# Design Review Board Agenda

**CITY OF MILL CREEK  
DESIGN REVIEW BOARD  
APPLICATION PL2018-0005**

**NAME OF PROJECT:** Canyon Creek Church

**NAME OF PROJECT:** Gateway Shopping Center Exterior Remodel – Phase II

4 PLANTER / TRELLIS DETAIL

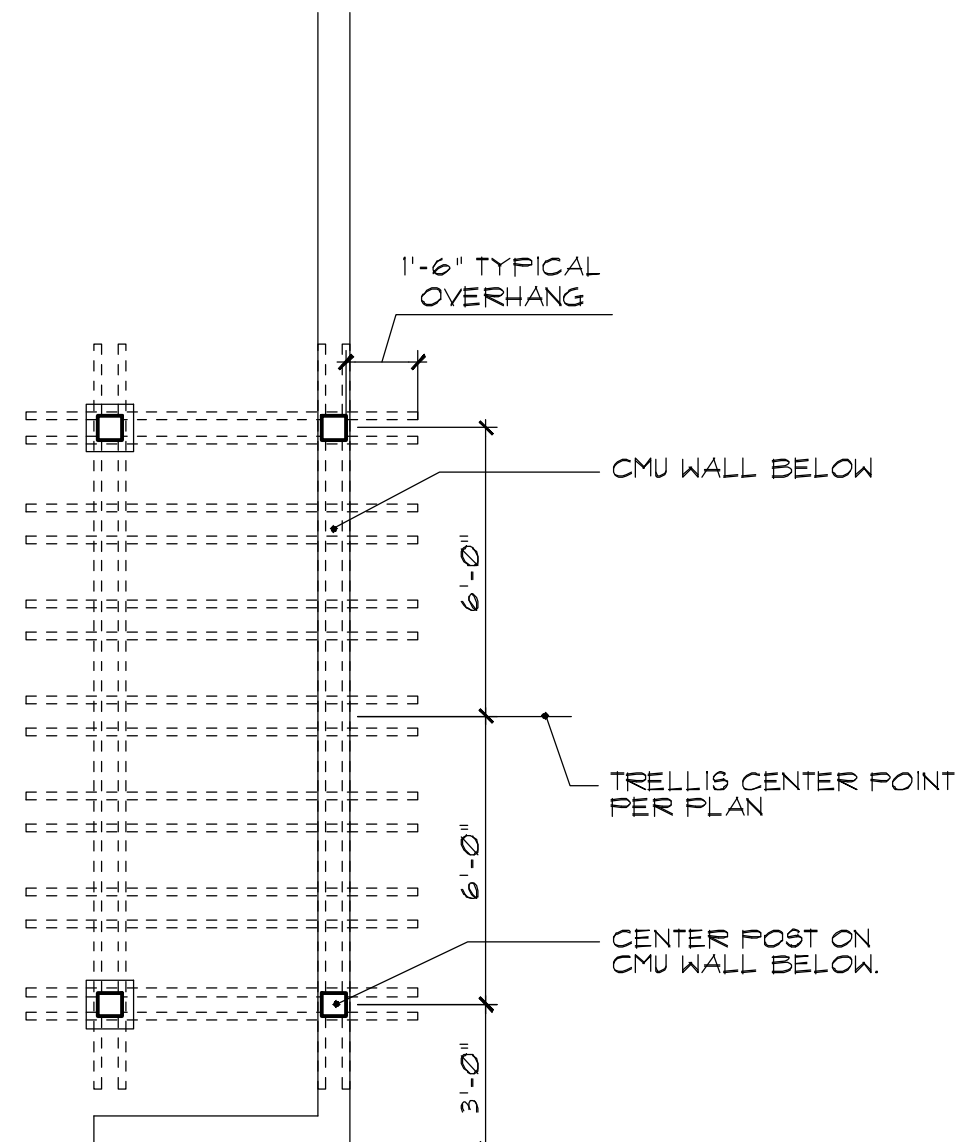
The applicant has addressed the DRB concerns (listed in the Background section of this report) on the northern façade by flipping the layout of the building and screening the rooftop equipment. In addition, the applicant did provide a break-up in the western façade on the 49 foot wall by adding a trellis, and on the southern façade the applicant is proposing to break-up the 79 foot wall with two trellises. The applicant is proposing to plant these three trellises with Climbing Star Jasmine.

2. Amend the landscape plan as follows:
  - Add Climbing Star Jasmine to the plant legend to be planted on the building trellis's on the western and southern facades.

EXTERIOR  
ELEVATIONS

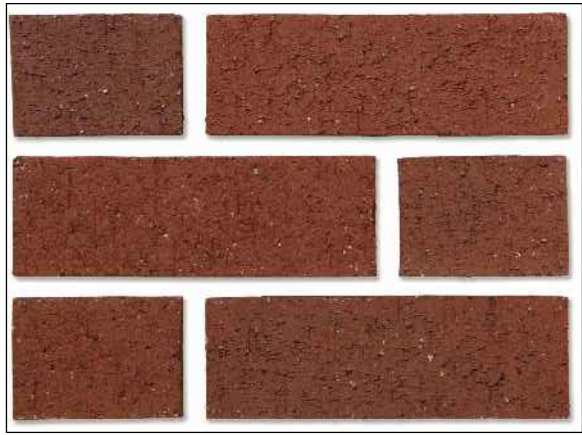
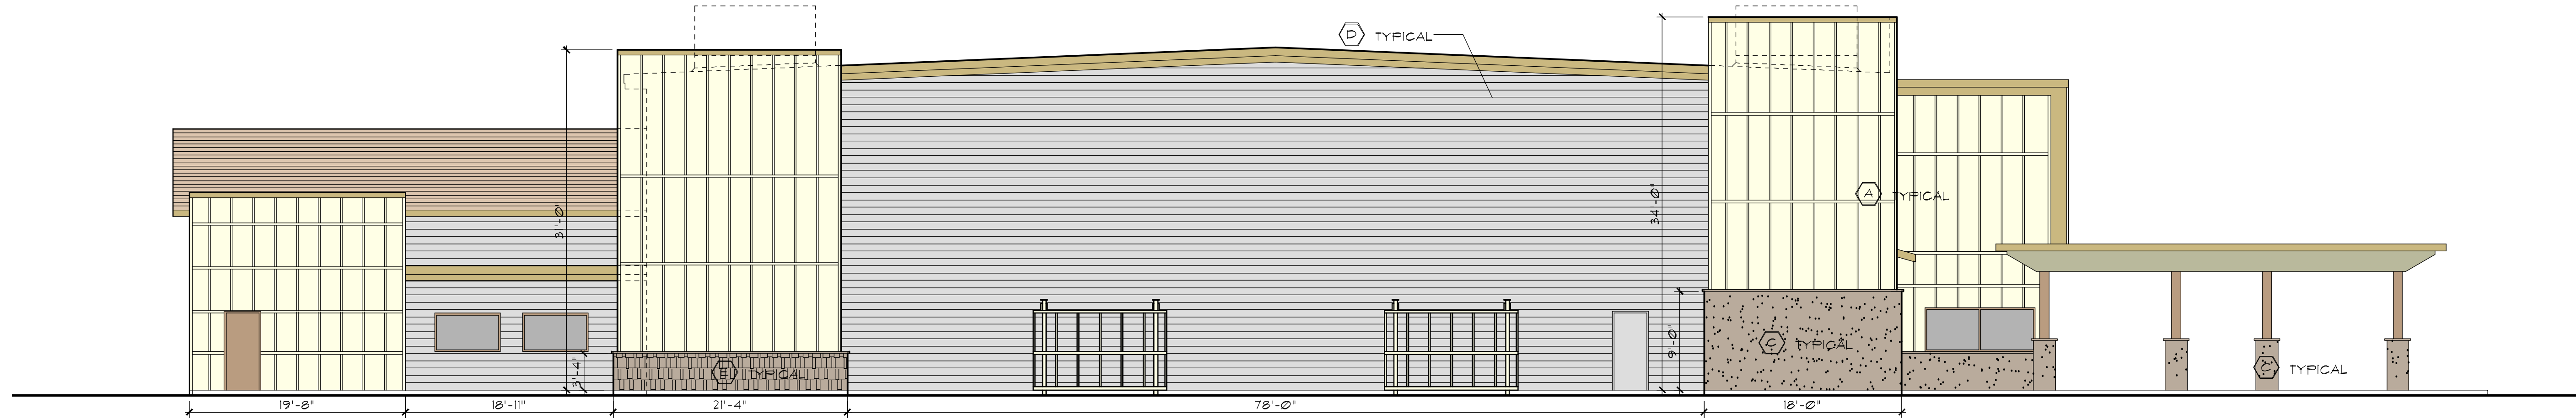
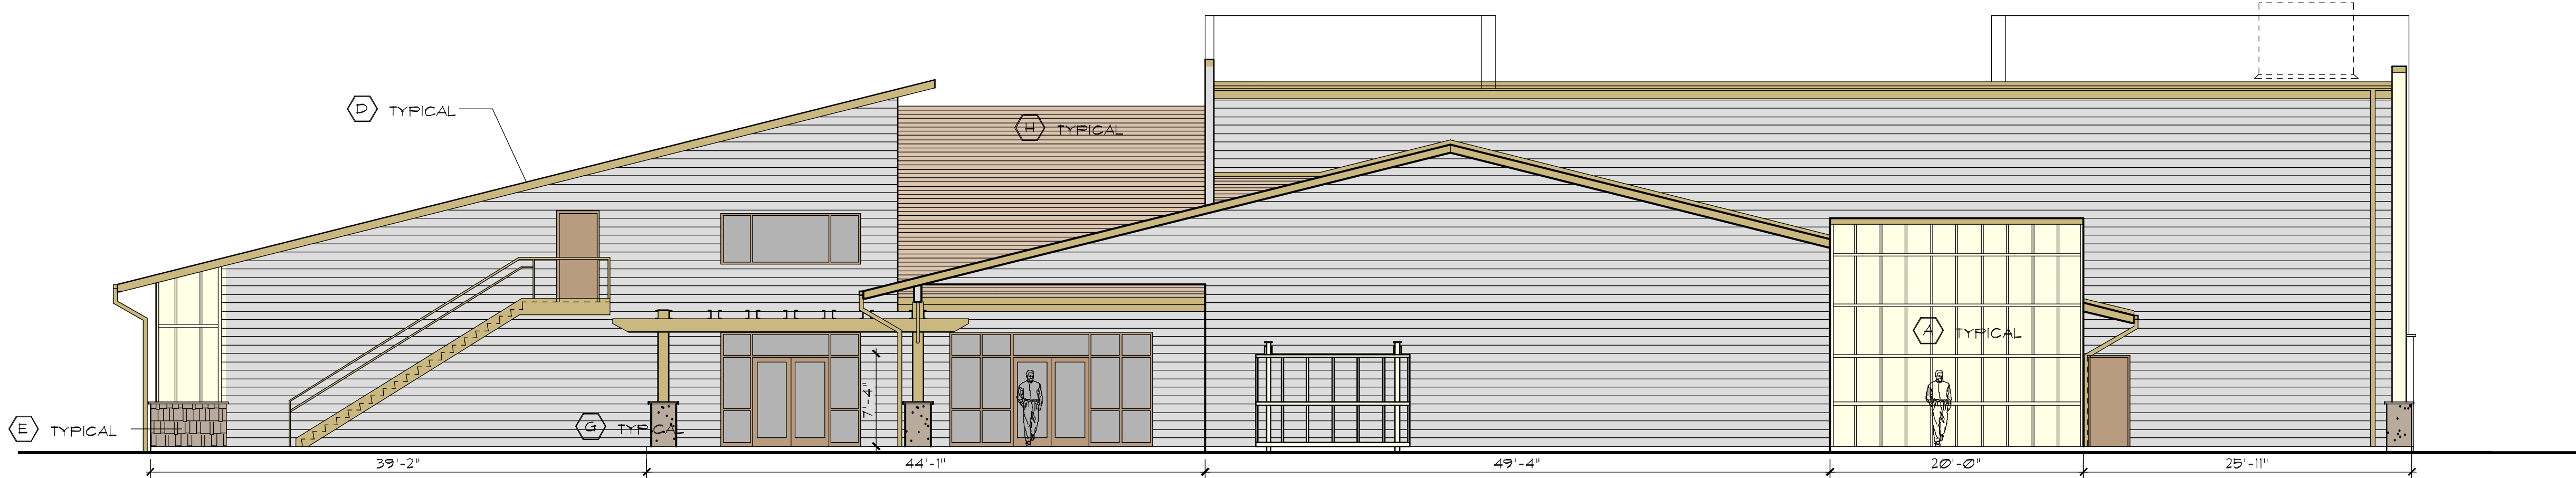
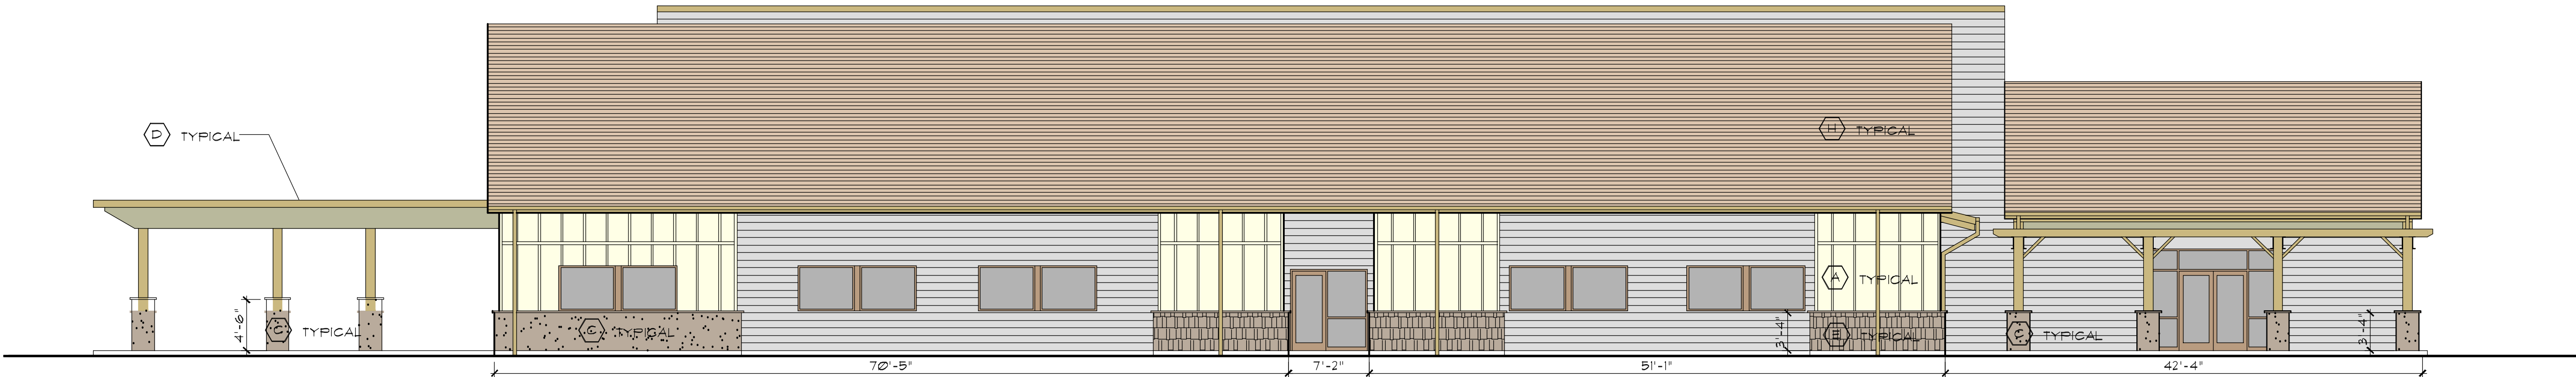
The rooftop mechanical equipment will be screened from view from the public right-of-way by the building parapet.

As proposed, staff believes that the building elevations are in compliance with the design guidelines contained in the Code and is recommending approval with the Condition of Approval that the applicant add Climbing Star Jasmine to the Landscape Plan planting legend.

PRELIMINARY LANDSCAPE PLAN  
CANYON CREEK CHURCH

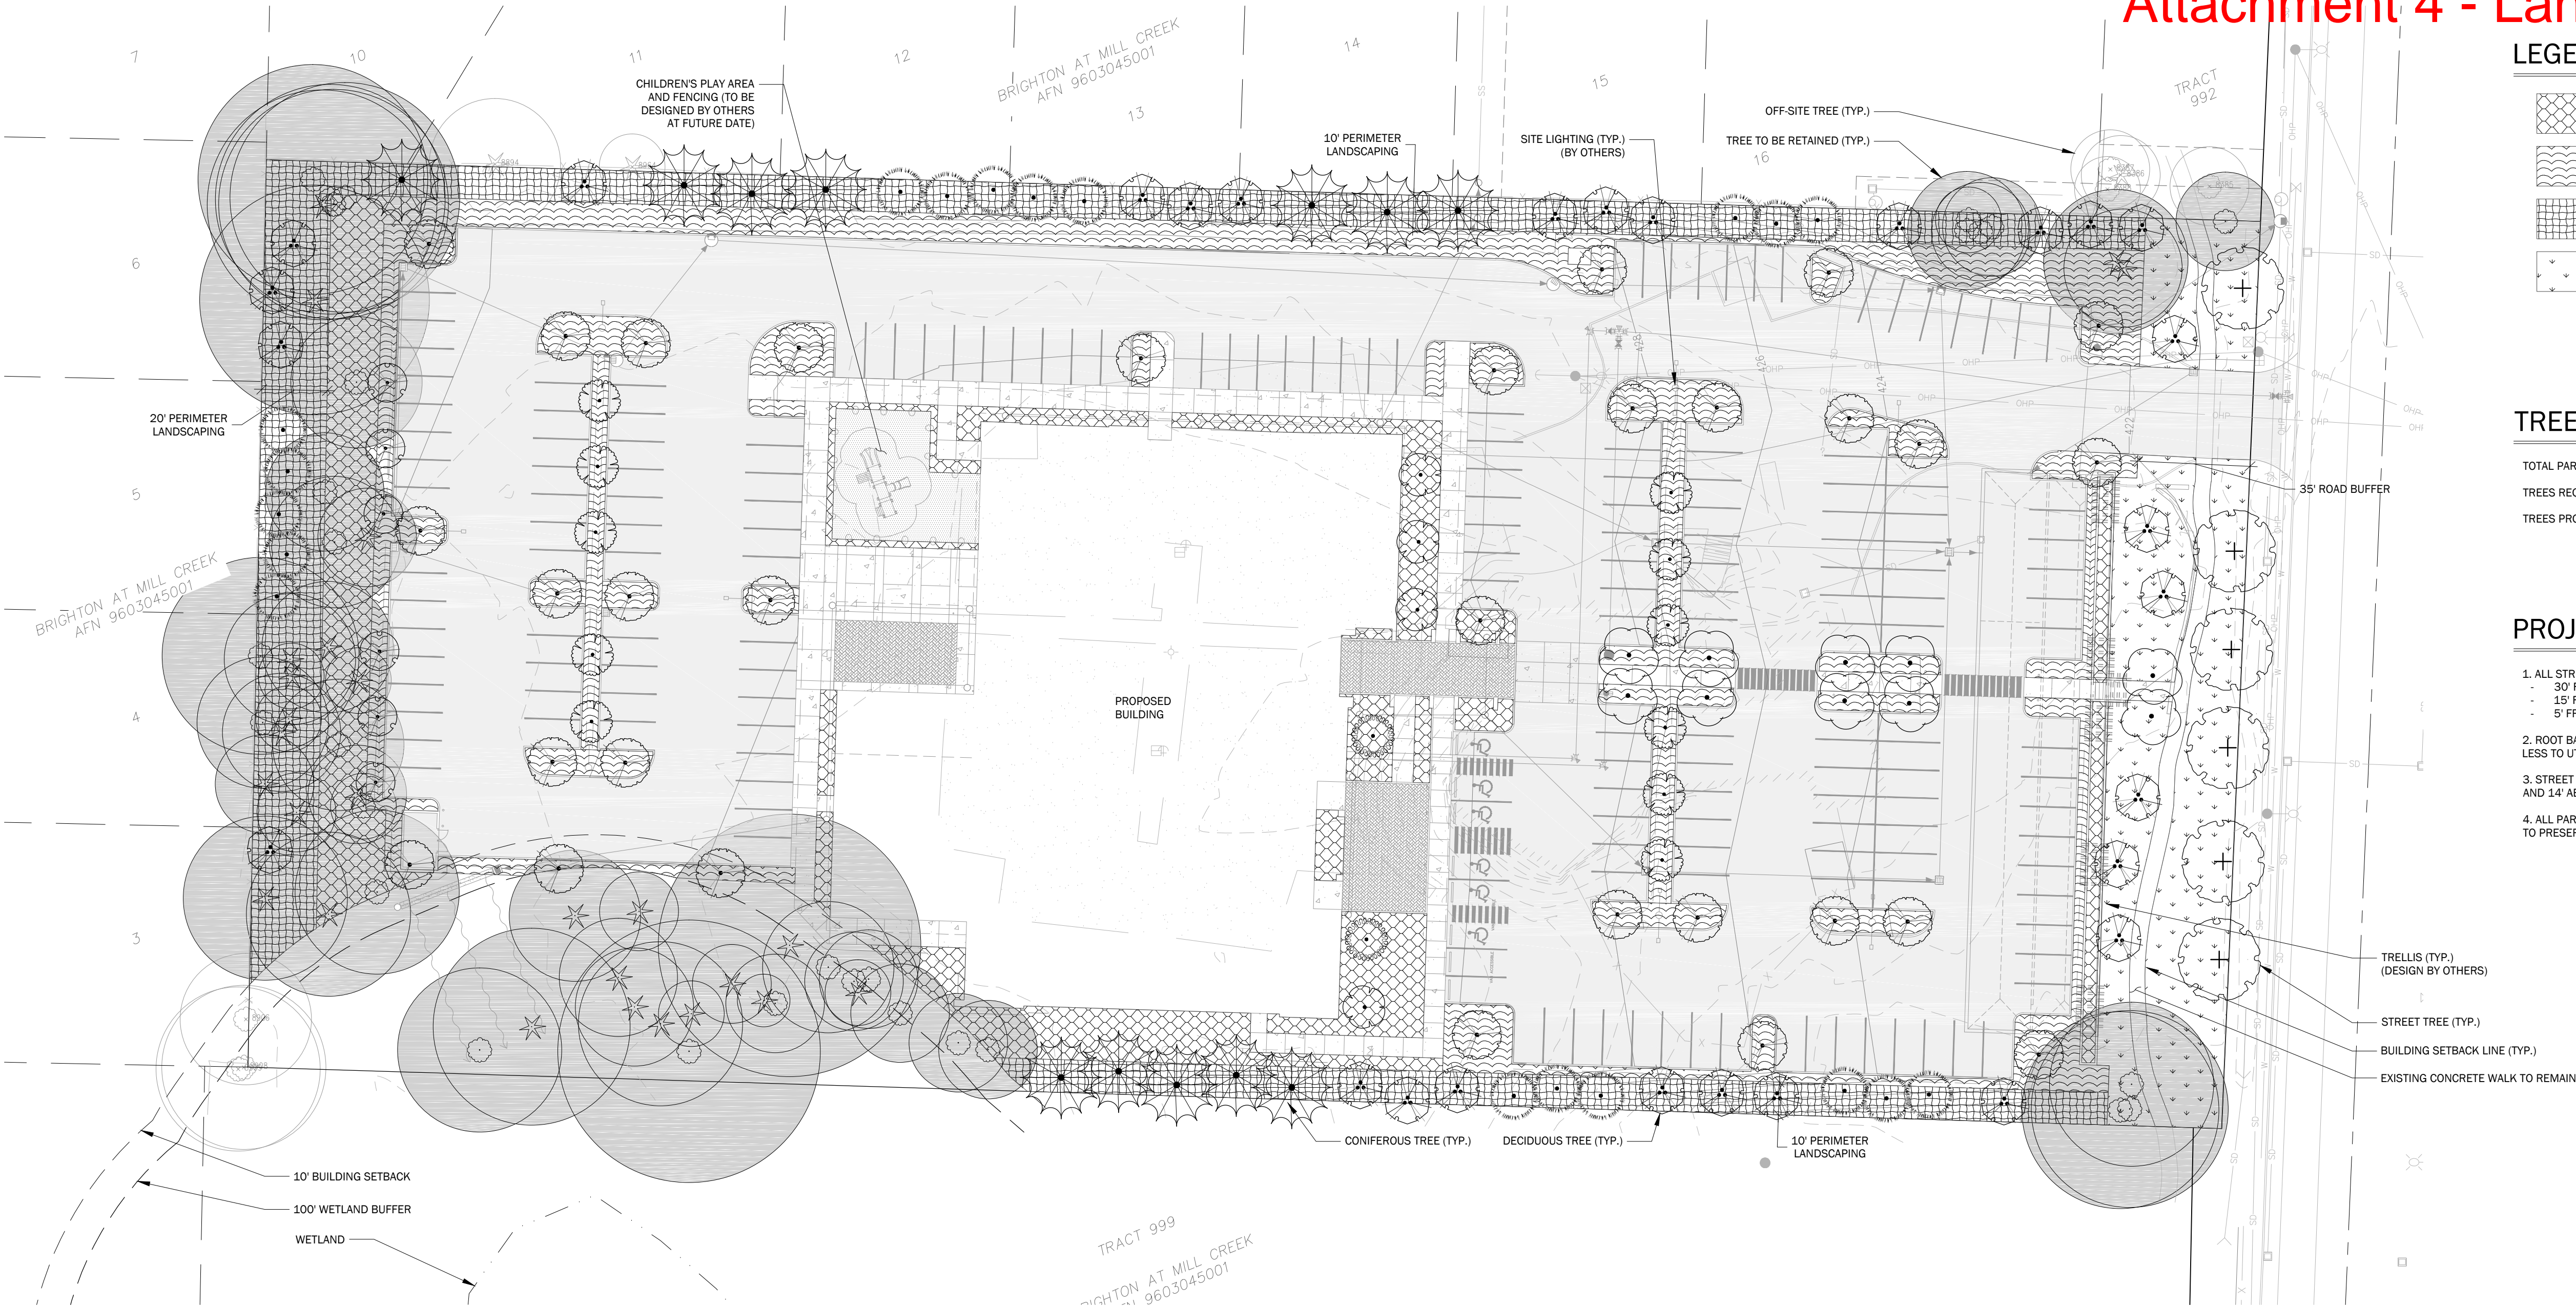
- Replace the Western Sword Fern in the parking lot landscaping with another evergreen shrub, as staff has seen in past applications that sword fern is not a successful plant selection for a parking lot.
- Install trees of varying heights with a minimum height of 8 feet to 12 feet in height to provide a natural appearance and increase the visual vegetative screen along the western and northern property lines.

- Replace the Western Sword Fern in the parking lot landscaping with another evergreen shrub.
  - Install trees of varying heights with a minimum height of 8 feet to 12 feet in height to provide a natural appearance and increase the visual vegetative screen along the western and northern property lines.

- Add the monument sign location on the landscape plan with the five foot property line setback.
3. A landscape performance bond in the amount of 125% of the proposed cost of materials and installation shall be provided to the City prior to beginning construction of the binding site plan, pursuant to MCMC Section 16.16.040.
